Access Compliance Report

Public Rights-of-Way (Curb Ramps)

Intersection ID: 45694	Main Street: E_ARROWWOOD_RD	Cross Street: SILVER_ARROW_DR	Location: SW
ADA ID: D52572D75A75	Ramp Type: PerpDiag	Initial Pass/Fail: Fail	Overall Compliance: No Severity Score: 58.75

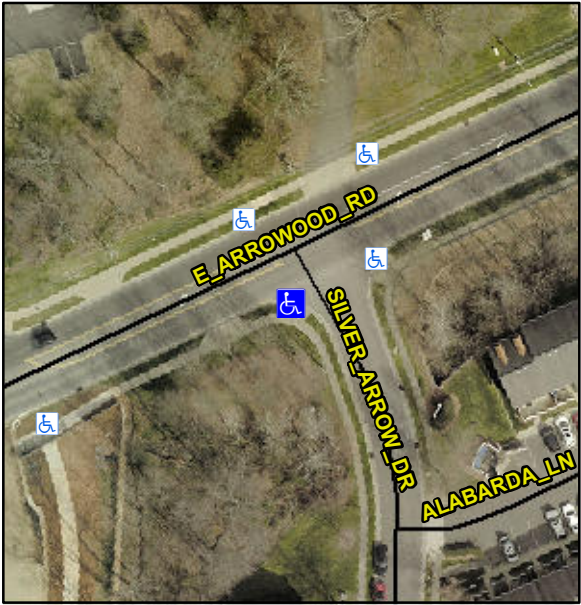
Codes/Mitigation Info/Possible Solution		Field Measurements/Component Compliance			
	Possible Solutions:				
	Remove & Replace Curb Ramp With Two New Directional Ramps or Equivalent.				
	Surveyor Notes:				
	N/A				
	PROW/ADA:				
	R304.5.1, R304.2.2, R304.5.3				
	Street 1 Name	SILVER ARROW DR			
	Stop Condition-Street 2	StopSign			
	Street 2 Name	E ARROWOOD RD			
	Stop Condition-Street 1	None			
Total Cost:		\$	3200.00		
Compliance	Description	Data	Compliance	Description	Data
N/A	Ramp Length (in)	59.5	No	Ramp Slope (%)	12.2
No	Ramp Width (in)	42.0	No	Ramp XSlope (%)	12.3
N/A	Flare Type LT	N/A	N/A	Flare Type RT	N/A
N/A	Flare Slope LT (%)	N/A	N/A	Flare Slope RT (%)	N/A
N/A	Flare Traversable LT?	N/A	N/A	Flare Traversable RT?	N/A
N/A	Landing Length (in)	N/A	N/A	DWS Provided?	N/A
N/A	Landing Width (in)	N/A	N/A	DWS Contrast?	N/A
N/A	Landing Slope (%)	N/A	N/A	DWS Length (in)	N/A
N/A	Landing X Slope (%)	N/A	N/A	DWS Full Width?	N/A
